# PERMIT

## SEWAGE DISPOSAL SYSTEM

P 47005  
A REPAIR

RE: Building Permit Application  
Serial Number: 40378  
Proposed 2 Bedrooms & Office Addition  
2975 Florence Road

*Serial # 40378 Addition*

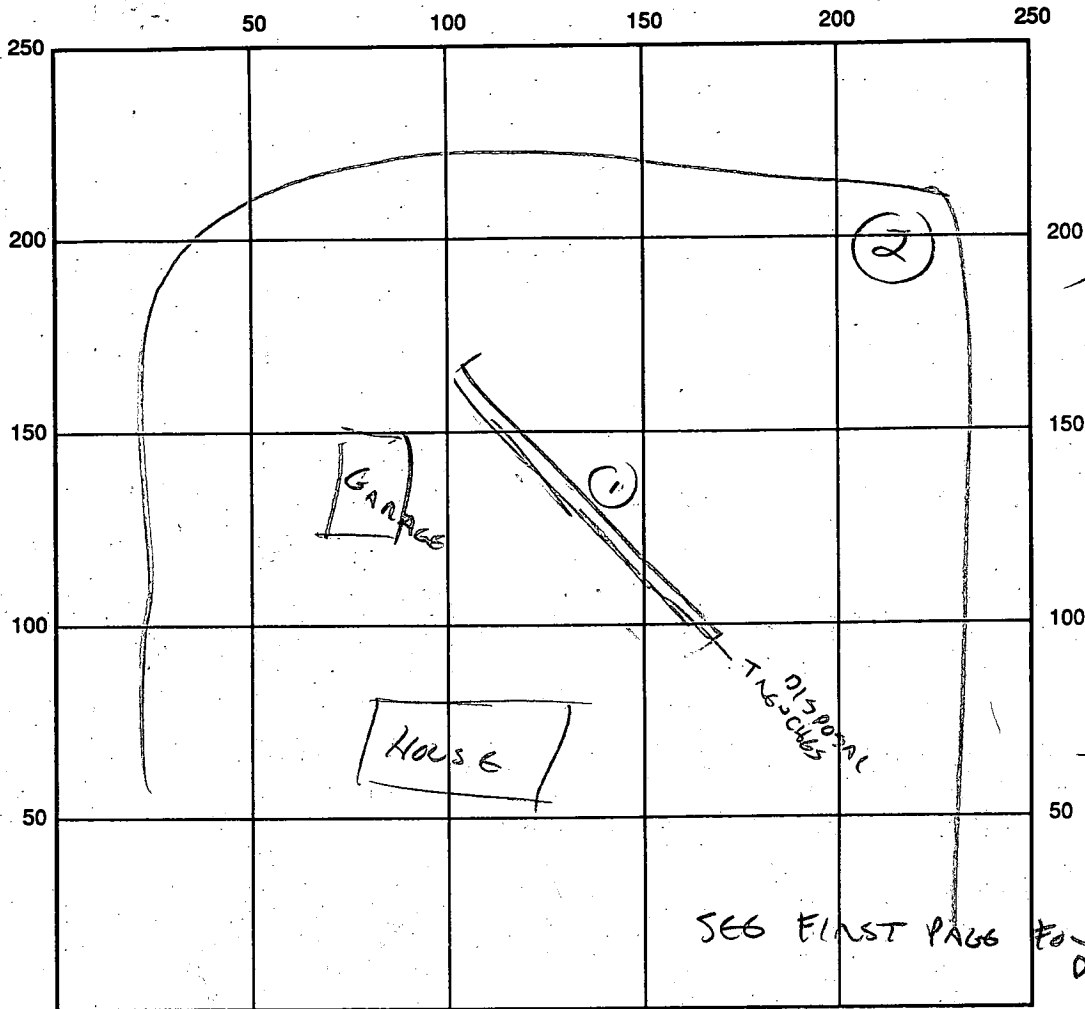
*(AT SITE)*  
(Install 1 house septic tank - 10' + from house and 10' + from cleanout before cleanout of (B) present up grade S. Tank; Need to see pipe on either side of (New) tank) and New septic tank before pouring @ 7/22/92

REMARKS: 7/23/92 BP 40378 RECOMMENDED FOR APPROVAL W/O  
INSISTING UPON RECOMMENDED TANK REPLACEMENT. APPLICANT INDICATES BAFFLES  
WON'T ADD TO EXISTING SEEPAGE PIT, INDICATES INTENT TO REPLACE TANK AT EARLIEST  
"CONVENIENT" OPPORTUNITY, CW

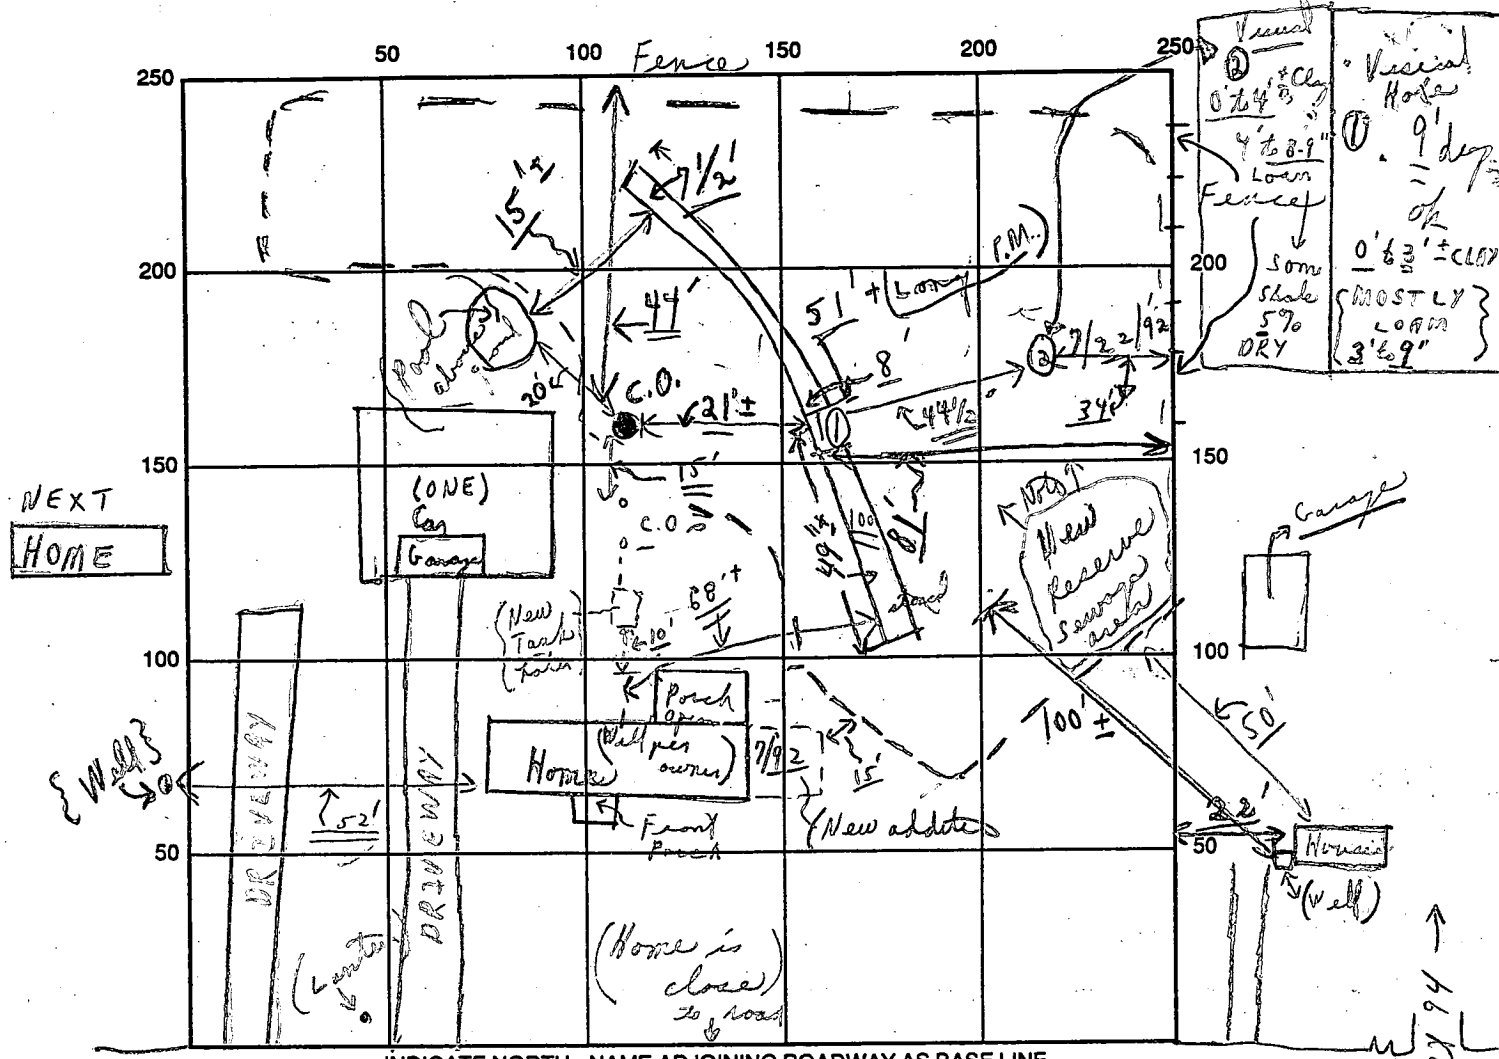
{ (1) 100' of trench; 1 1/2' wide; depth 2' 6 2/3', Man-hole depth 2' 4" of stone  
10' to 15' top of trench tanks (?) - C.B.S. - Run trench on contour

Visual  
 0'64" ± clay  
 4' to 8.9" Low  
 Fence  
 Somewhat  
 Shale  
 5%  
 DRY

Vertical  
 Hole  
 9' deep  
 0'63" ± clay  
 { MOSTLY }  
 LOAM  
 3'6.9"

SEPTIC TANK LEVEL OLD TYPE CLEANOUTS "Edistering"  
 (New one later)  
 DISTRIBUTION BOX LEVEL MAY USE A "T"  
 DRAIN FIELD/TITLE DEPTH 7 1/2' ± average FT. TRENCH WIDTH 1 1/2 FT. INLET DEPTH 2 1/2' ± FT.  
 EFFECTIVE GRAVEL DEPTH 4' ± FT. TOTAL LENGTH 100' FT. Early 5/31 End of trench open only  
 (TO BE) (400 ±) P.M.  
 NUMBER OF TRENCHES 1 ONE SIDEWALL/BOTTOM AREA 400 SQ. FT.  
 DRYWALL INSIDE DIAMETER      FT. EFFECTIVE DEPTH BELOW INLET      FT.

REMARKS: 4/25/91 P.M. - NO WORK STARTED; SPOKE TO OWNER AT HIS HOME OVER THE PHONE - APPT. FOR 8:30 A.M. - 4/26/91 AT SITE  
{ 4/26/91 - 8:30 A.M. } - (1) Trench to be dug and checked later in P.M. - THEY ARE TO KEEP (?) OLD TANK PUMPED OUT; C.B.S.  
4/26/91 - Partial - TRENCH OK TO PUT STONE IN TRENCH - AS CONTINUE; 55' ± OPEN; 4/29/91 EARLY INSPECTION - SEE BELOW

RAIN 4/29/91 P.M. Trench & work @ edistering tank still not complete  
 HOLD FOR A CALL ON-FINAL OF TRENCH; 5/2/91 P.M. MORE - Pipe in trench  
 STONE AT SITE - DOGS IN YARD
